Report for BCA Compliance

PROJECT NAME: Sikh Grammar School Sydney (Rouse Hill Campus) – SSDA Submission

DATE: 3 May 2019

01 PLAN
 Level -1 (Basement Carpark)
 Scale 1:250

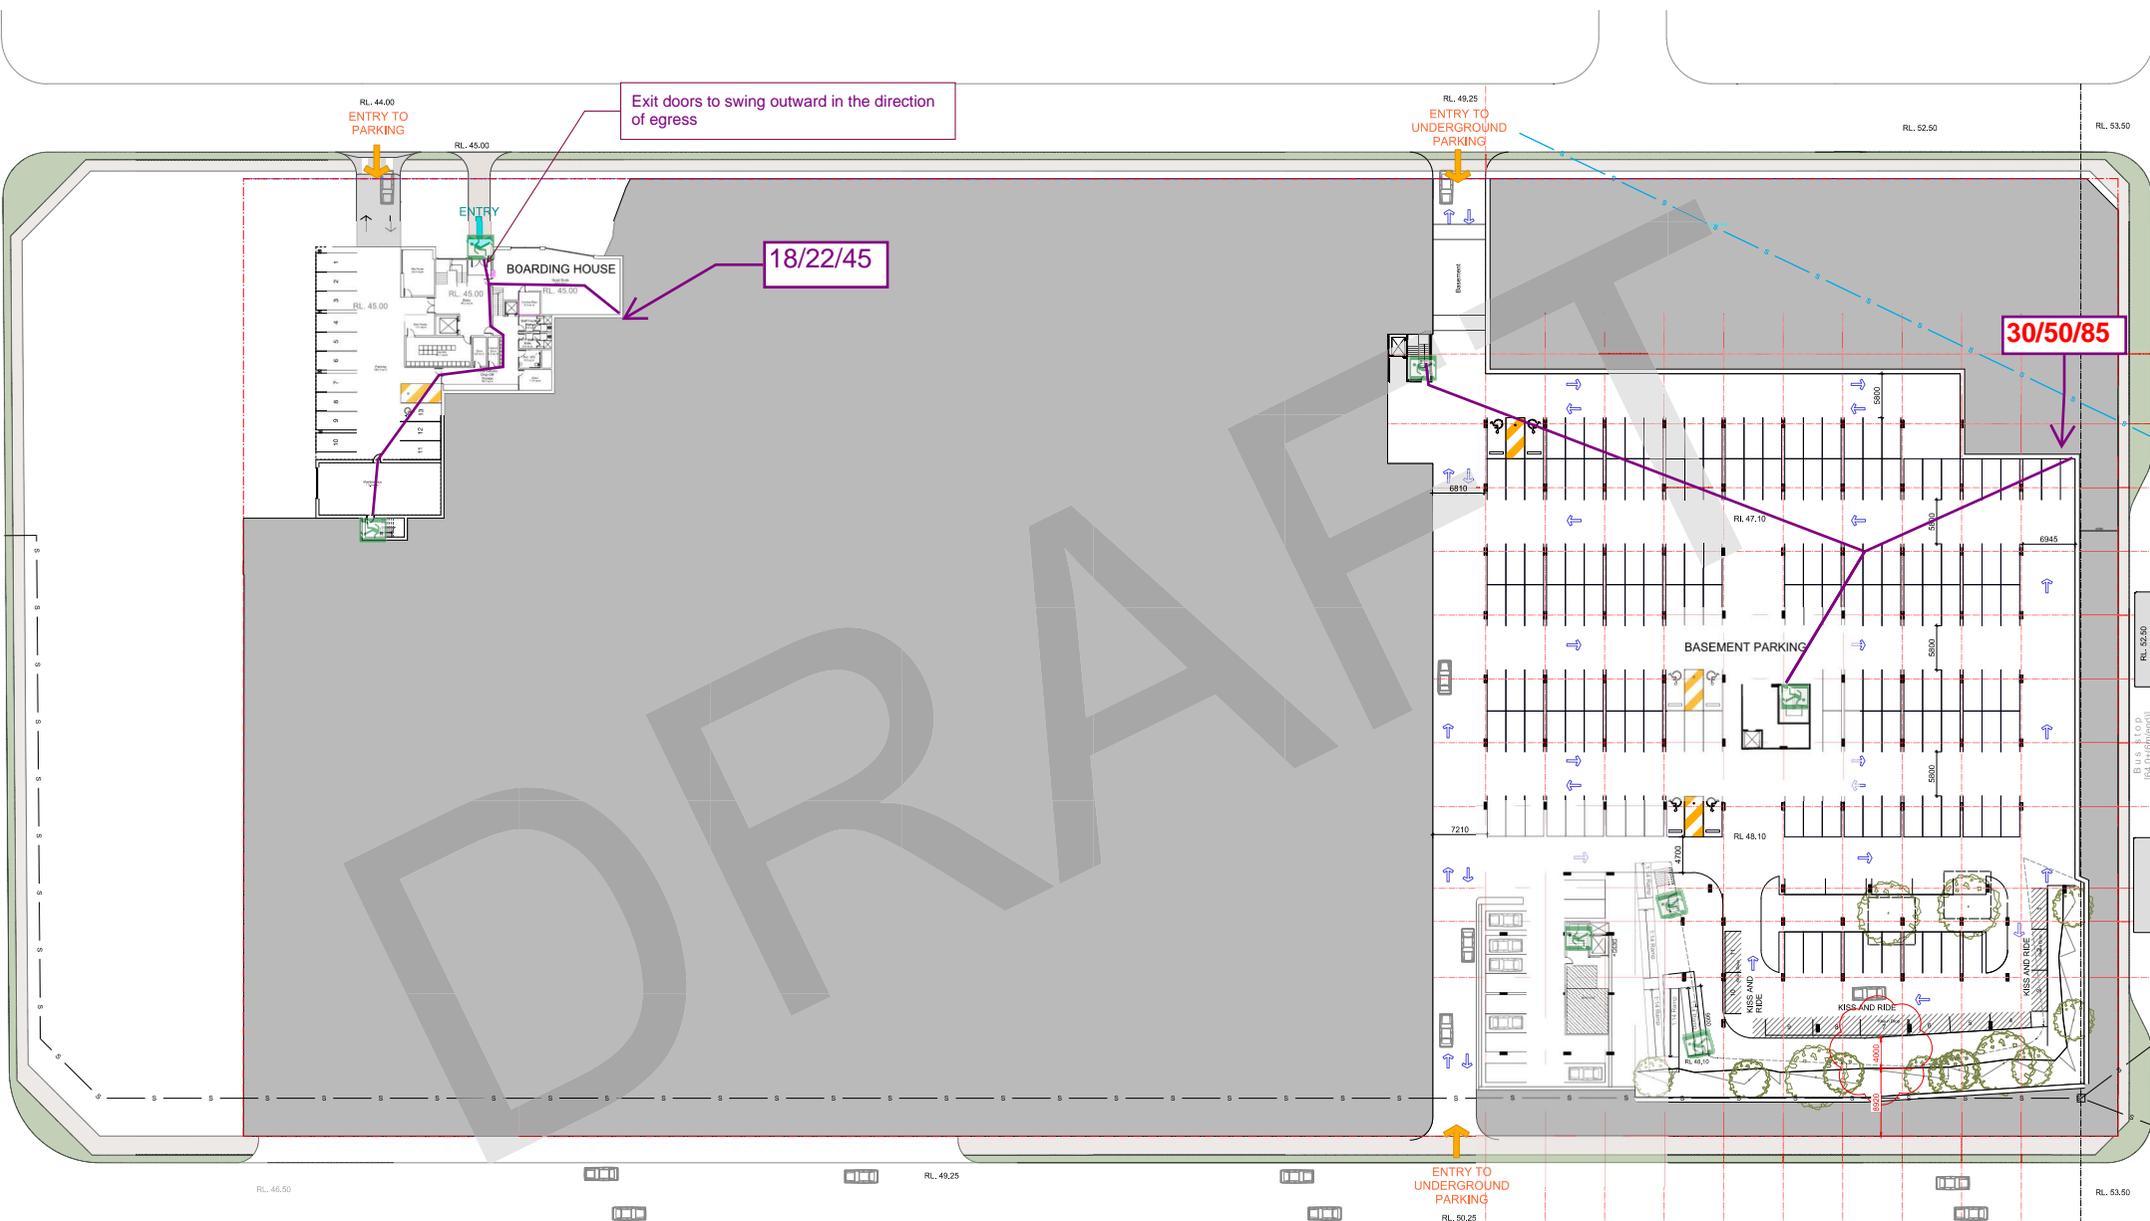
Location	DTS Travel Distance Requirement	Actual	Design Team Nominated Resolution
			Solution.
School Complex – Basement Carpark – Worst Case	20/40/60	30/50/85	Fire Safety Engineer to review and advised if this issue is justifiable as a Performance Solution.
School Complex – Secondary School - level 1 – Worst Case	20/40/60	30/35/46	Fire Safety Engineer to review and advised if this issue is justifiable as a Performance Solution.
School Complex – Primary School - level 1 – Worst Case	20/40/60	25/31/43	Fire Safety Engineer to review and advised if this issue is justifiable as a Performance Solution.
School Complex – Secondary School - level 2 – Worst Case	20/40/60	27/34/49	Fire Safety Engineer to review and advised if this issue is justifiable as a Performance Solution.
School Complex – Primary School - level 2	20/40/60	27/32/41	Fire Safety Engineer to review and advised if this issue is justifiable as a Performance Solution.

01 PLAN
Level 2
Scale 1:300

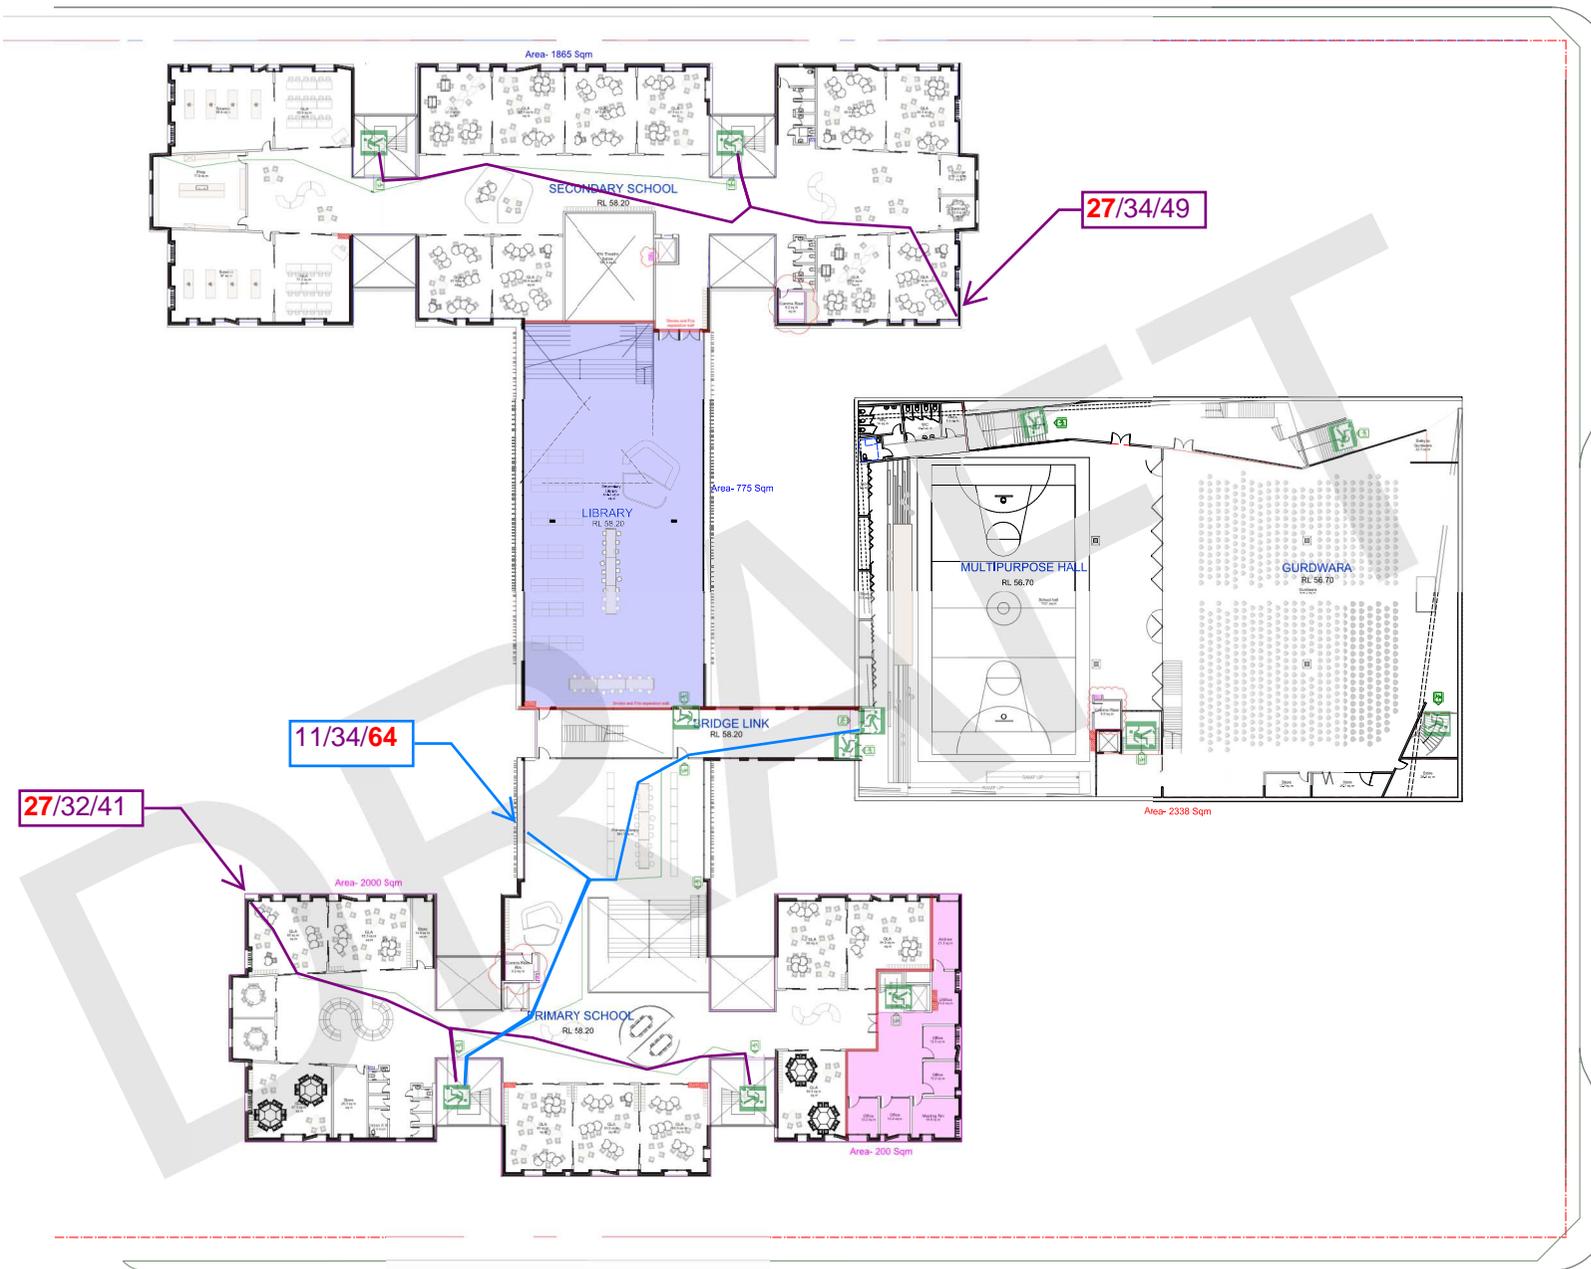
- a) Northern Library horizontal doors on Level 2. The northern horizontal Library doors on Level 2 require further egress review in relation to area served, number of occupants and direction of door swing, at the DD stage.
- b) Boarding House- LG external double doors. Plans to be updated to illustrate compliance.

01 PLAN- ELC and Boarding House
Level -1(Lower Ground)
Scale: 1:200

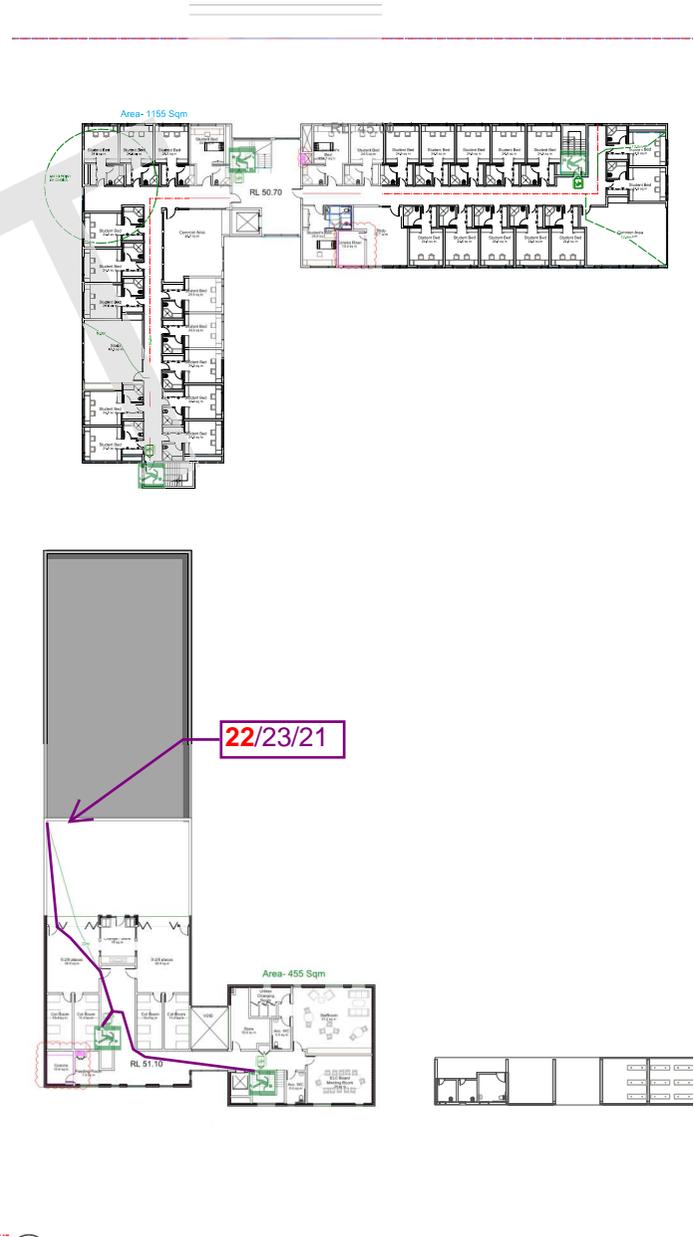
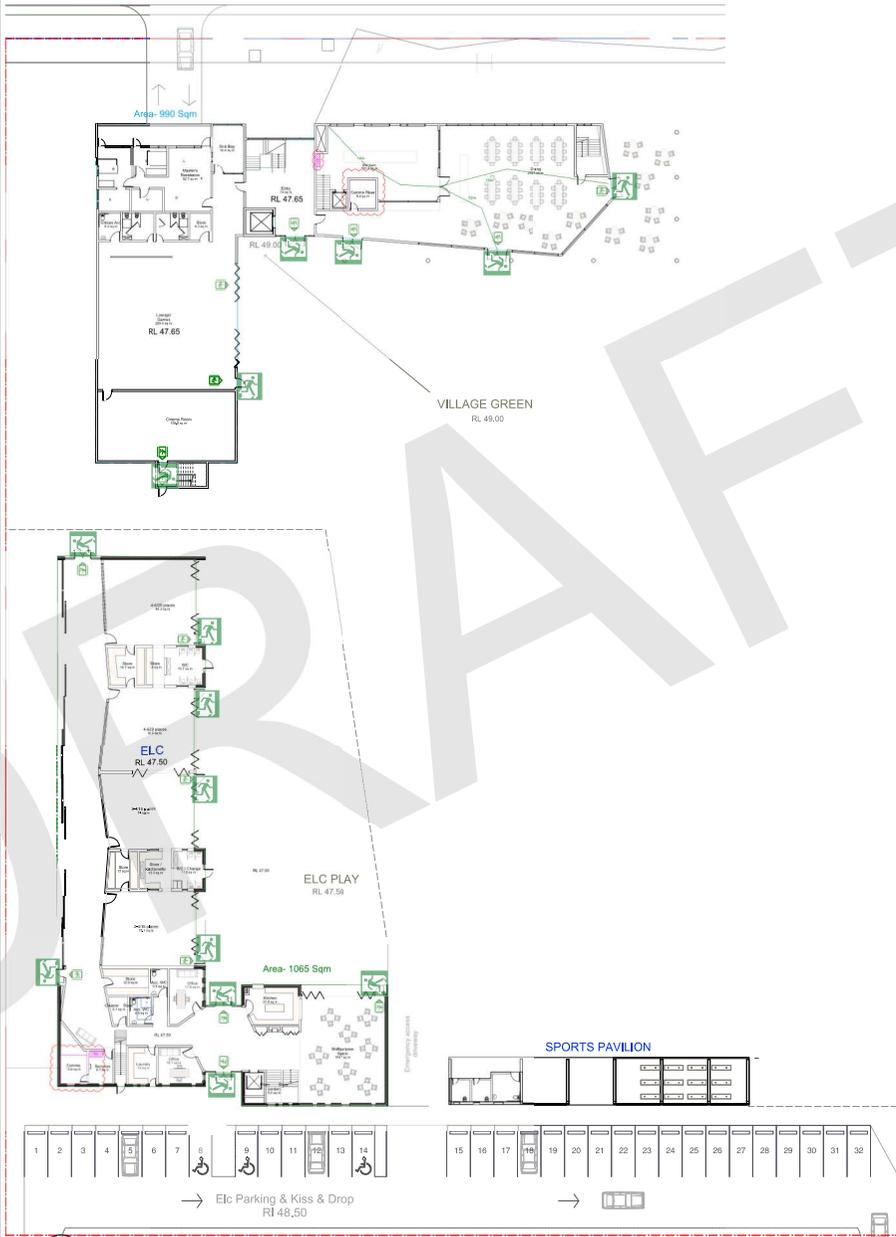
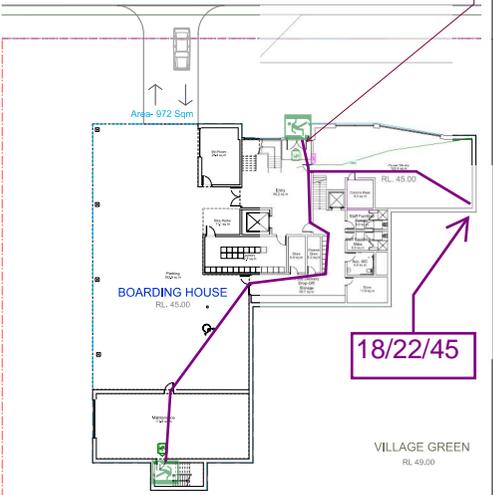
Exit doors to swing outward in the direction of egress.
